Puhoi to Warkworth

N1A Remediation Options - Technical Review Comments

P2WK-TAS-GE-TM-0010 | A

04 April 2023

Figure 2 NX2 Option 1 section.

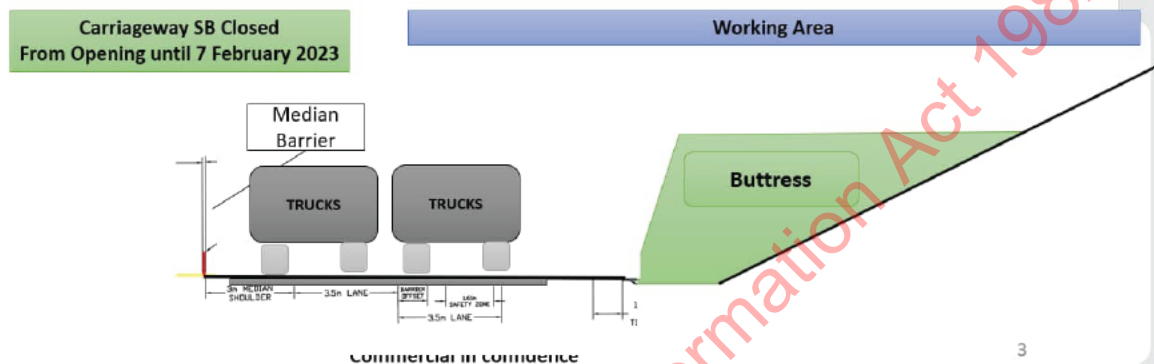
- Option 1 involves placement of a fill buttress at the base of the cut slope.
- In their presentation NX2 have shown an interpreted ground model section with two landslide slip surfaces at depth extending beneath the carriageway (Figure 2). The deepest shear surface is interpreted to be at a depth of about 6-8m below the base of the buttress. Therefore, if option 1 was implemented as shown by NX2 the buttress will not be ‘keyed’ into stable bedrock at depth.

- The performance of the buttress to stabilise the landslide when not keyed into stable bedrock requires a very robust knowledge of the ground model, slip surfaces and the landslide behaviour, with as many uncertainties as possible eliminated.

Figure 3 NX2's stability section for Option 1

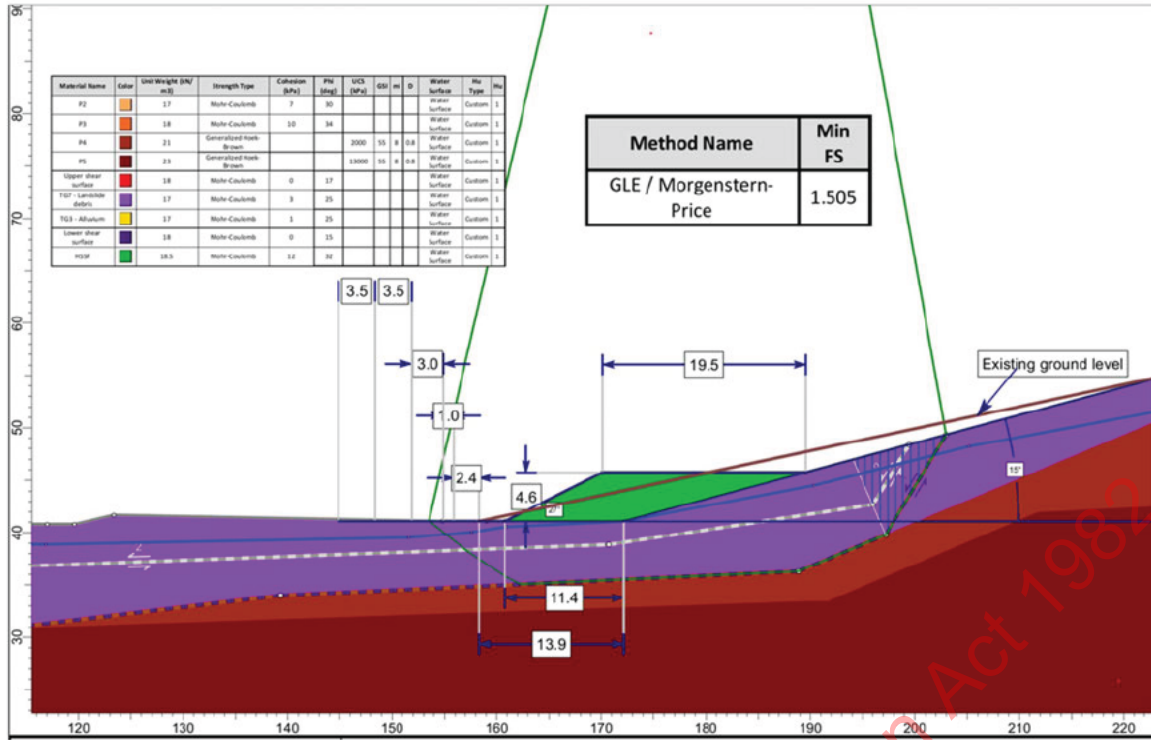
- While reprofiling the cut slope removes some of the material in the upper part of the cut, and the buttress acts as a toe buttress to further stabilise landslides involving the slope (red slip surfaces in Figure 3), there is the risk that the buttress destabilises potential slip surfaces existing beneath the carriageway (purple slip surfaces in Figure 3).

- Thus there is a risk that a fill buttress could have both positive and negative effects.

Figure 5 Options 2 and 3 section

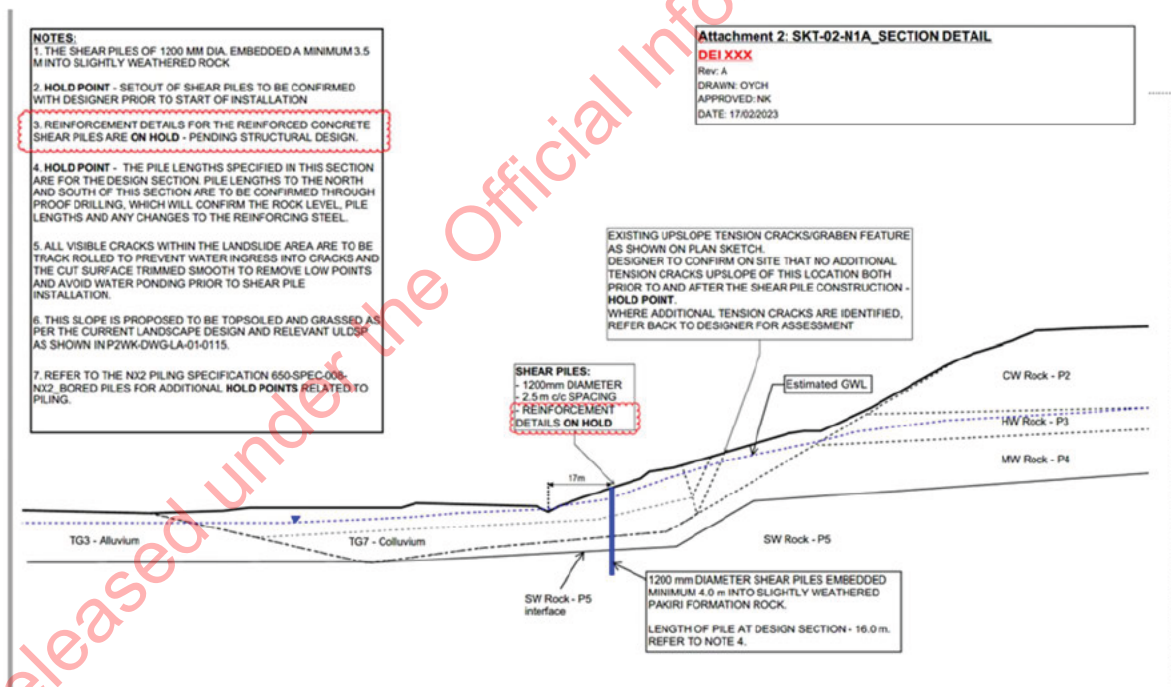
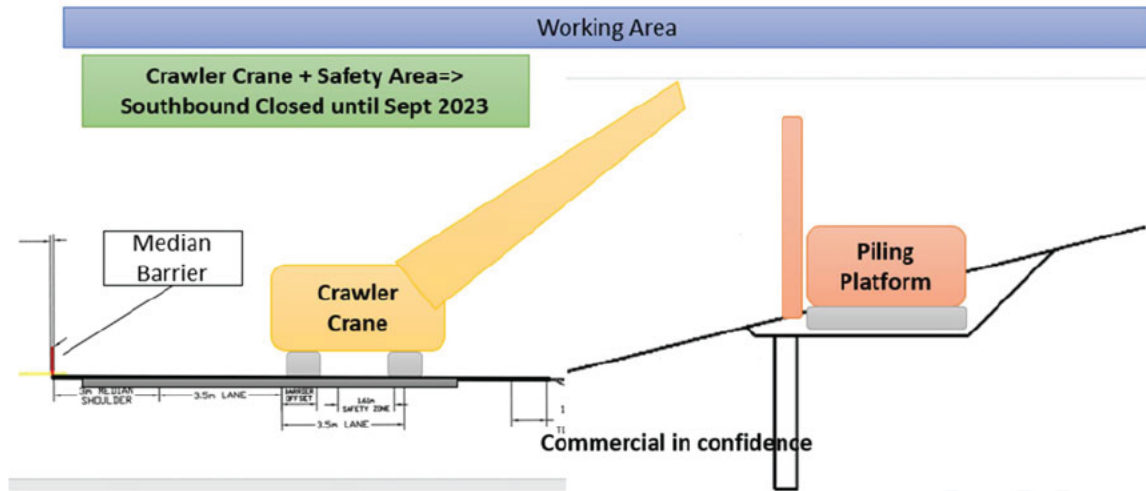
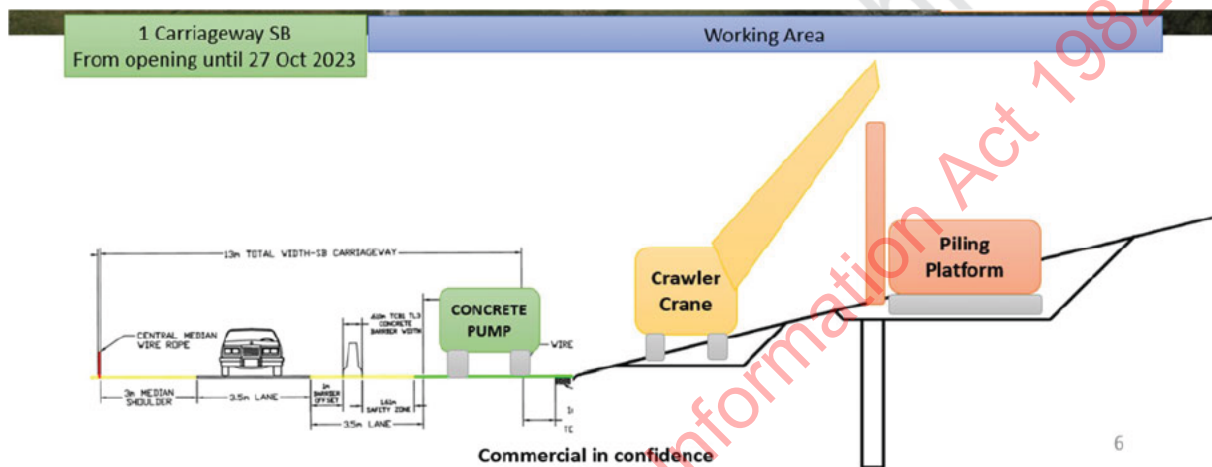
- The piled solutions involve providing a restraining force to the upslope portion of the landslide, and effectively reduces the driving force on the lower portion of the landslide. The slip surfaces are positively intercepted and reinforced.

- The potential instability on gently inclined slip surfaces to the west of the piles and beneath the carriageway is likely decreased. Although the landslide body and slip surfaces here would remain unrestrained, and therefore the remaining instability of the downslope landslide mass should be investigated and confirmed during detailed design.

- It is essential that the piles are embedded into underlying stable rock well below the lower slip surface. This would require a knowledge of the geometry of the lowermost slip surface in the direction along the row of piles. We note that the NX2 presentation shows a proposed hold point to confirm the pile lengths through proof drilling. TAS agrees with this approach and would recommend that adequate proof drilling is carried out in advance of the construction in order to adjust or confirm the design based on the drilling results.

- The lifting radius of a crane operating from the motorway for Option 2 will likely require a large crane. The surface of the motorway would need to be protected if the motorway is used as a crane platform. Any requirements to stop adjacent (live) traffic during lifting operations will also need to be factored in.

- The minimum width for the piling platform is anticipated to be around 6-8m to allow for safe operations. Temporary cuts for the platform will need to be excavated such that they do not exacerbate the existing slope instability.

Figure 8 Modified NX2 sketch to show potential rock anchor option for consideration

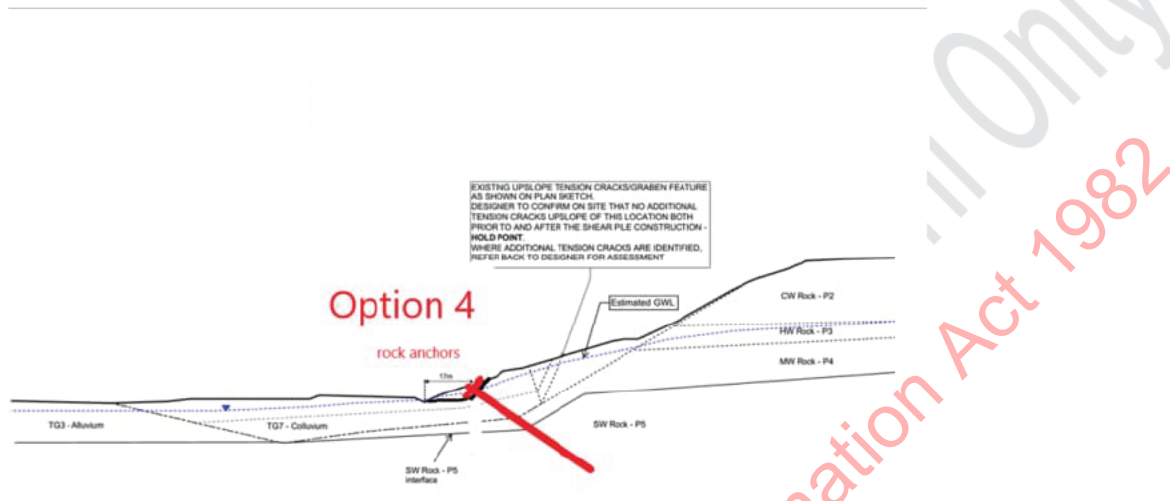
As an alternative deep rock anchors could be investigated as a possible solution requiring works to be performed along either one or two platforms on the slope face similar to Options 2 and 3. A second platform may be required if two rows of rock anchors are needed rather than a single row of rock anchors. The anchors would need large concrete pads to transfer anchor loads into the landslide mass. We expect that road closures for this option would be similar to that required for Option 3. Installation of rock anchors is likely to require smaller plant than that for Options 2 & 3.

A risk with Option 4 is that a better understanding of anchor founding conditions through further ground investigations would be required so that when installation of the anchors begin the risk of longer anchors being required is minimal. Trial anchors would need to be drilled and load tested to confirm anchor design prior to construction.
